McWANE CAST IRON PIPE CO.

July 12, 1960

REPORT ON CORROSION COMPLAINT AT PORT SULPHUR, LA.

I am attaching a sketch of the present and proposed route of the 10" pipe line.

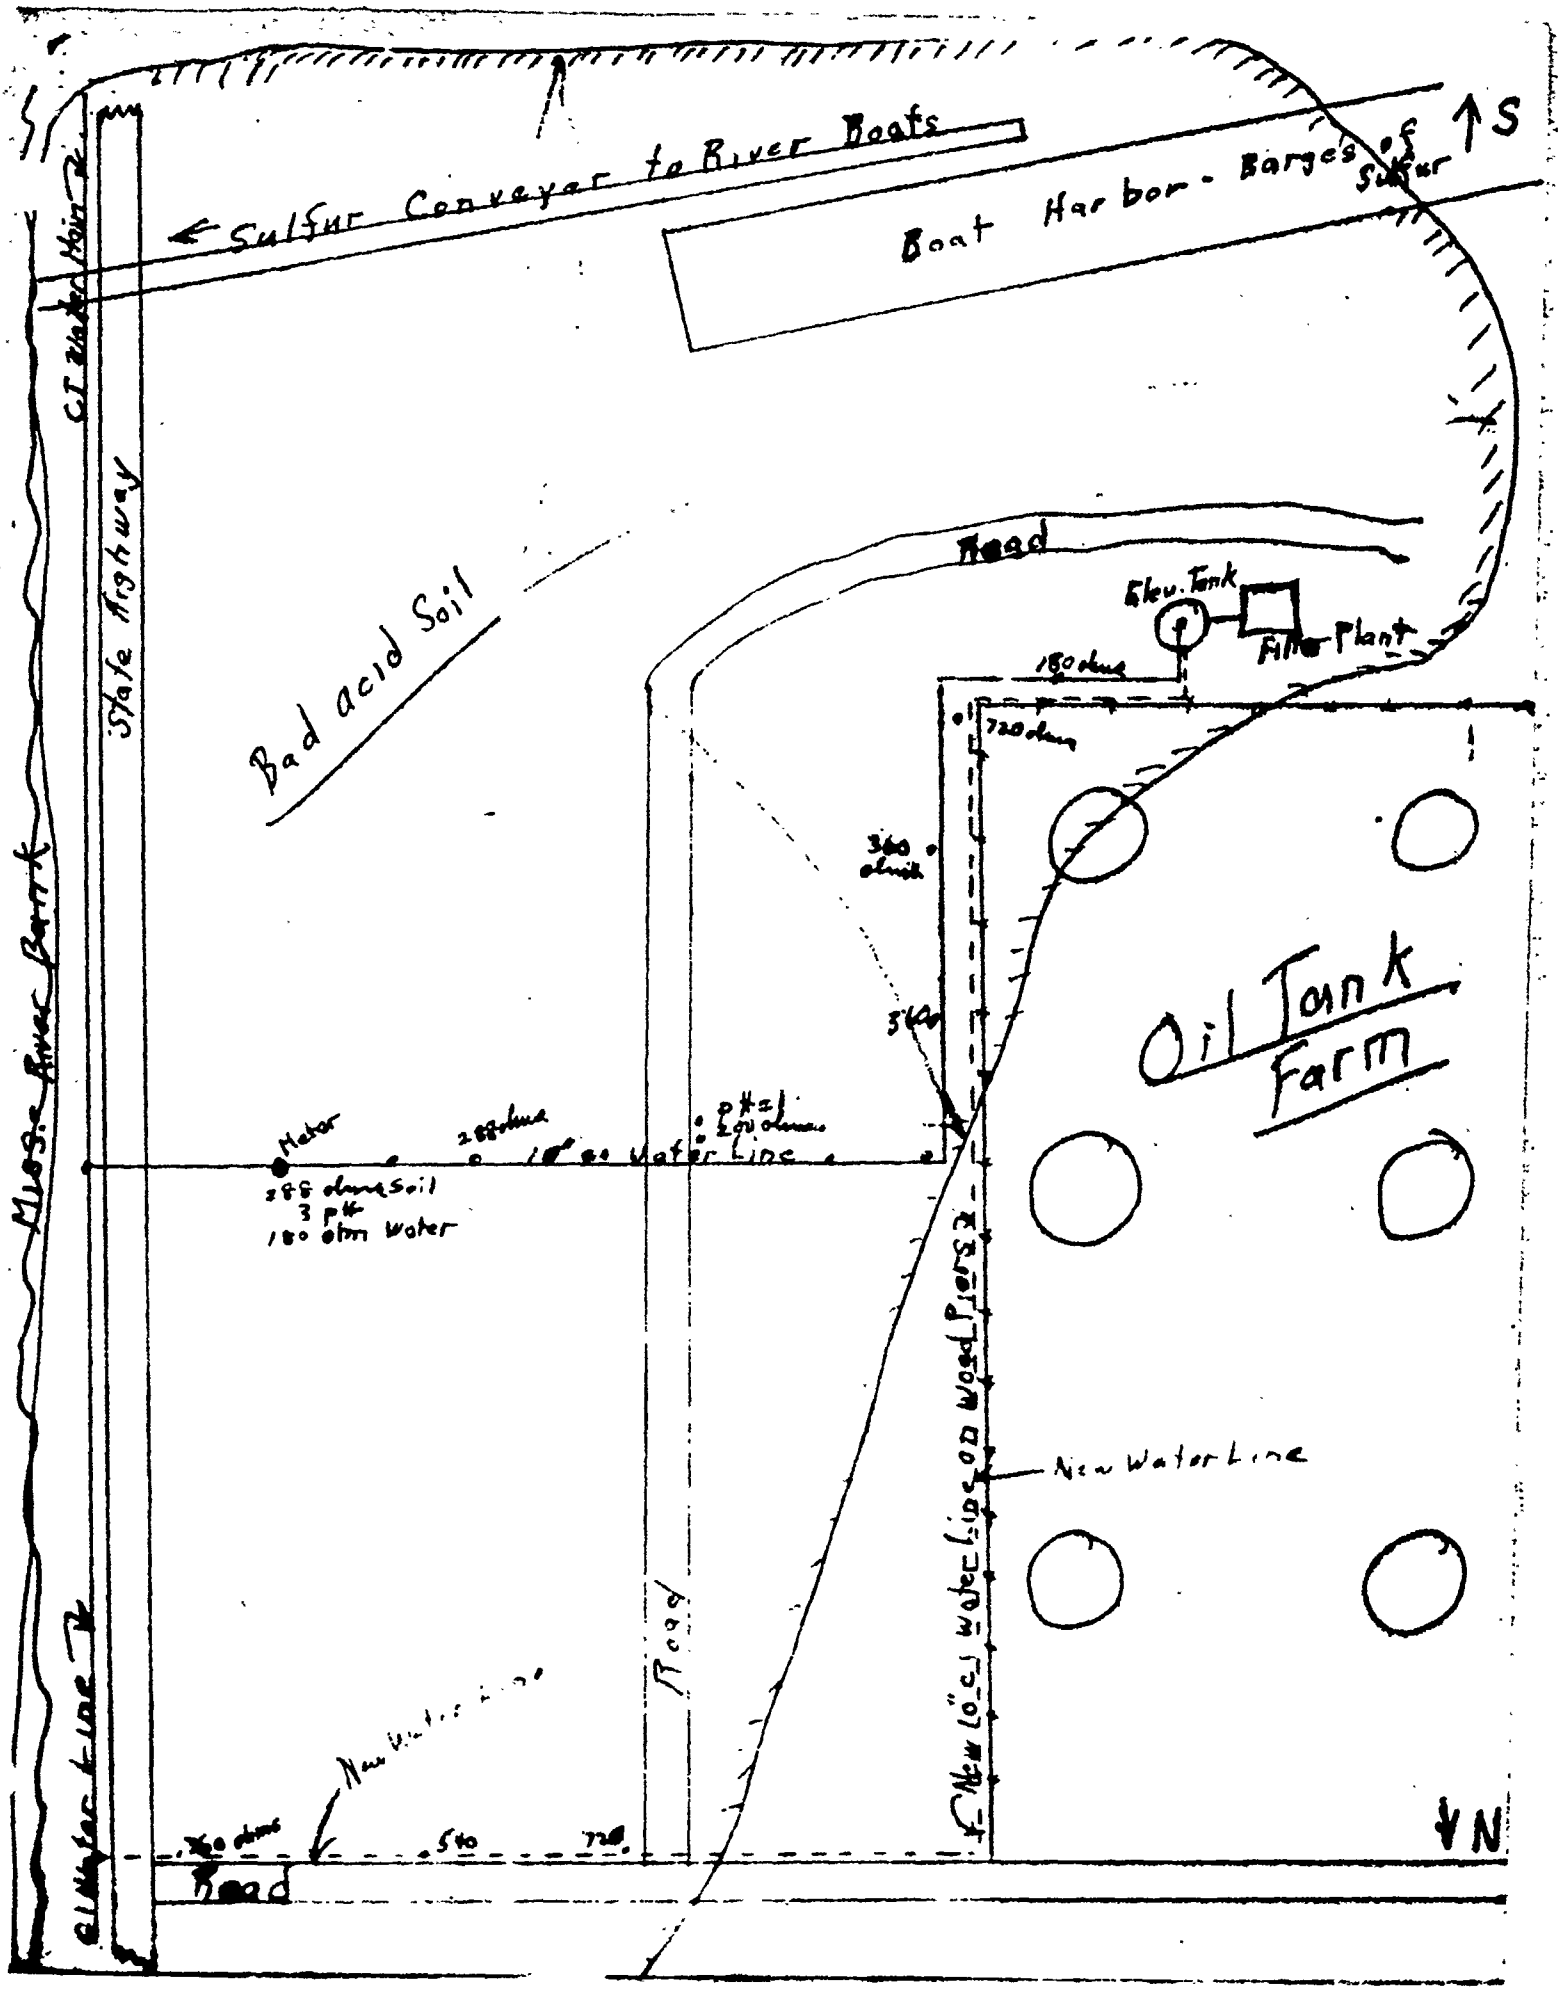
The soil conditions along this 1800 ft. of pipe are very bad and a short life would be expected. The trouble started in the

area of the water meter. The water table was only 8" below the ground surface and the soil would be saturated at all times.

I would suggest that the pipe line be replaced or relocated. The new pipe line should be installed above ground on creosote piers of 10" x 10" with at least 2½ ft. in the ground. The pipe should be securely strapped to the top of each pier, one pier for each length of pipe so that there will be no room for longitudal movement. At the ends of the lines and wherever there is a change in direction, the pipe should be securely tied together with steel rods and anchor clamps. After the pipe is installed, it should be given a good coating of bitumastic paint #50.

The route of the new pipe line should be as far away as possible from the equipment handling the sulphur. In other words, the water main should be laid as far north on the property as possible.

The water meter should be removed from the pipe line, inasmuch as it is never used and has never registered. The bronze metal parts only accelerate the corrosion. If it is desired to have the meter in the line, it should then be placed above ground on a concrete pad.
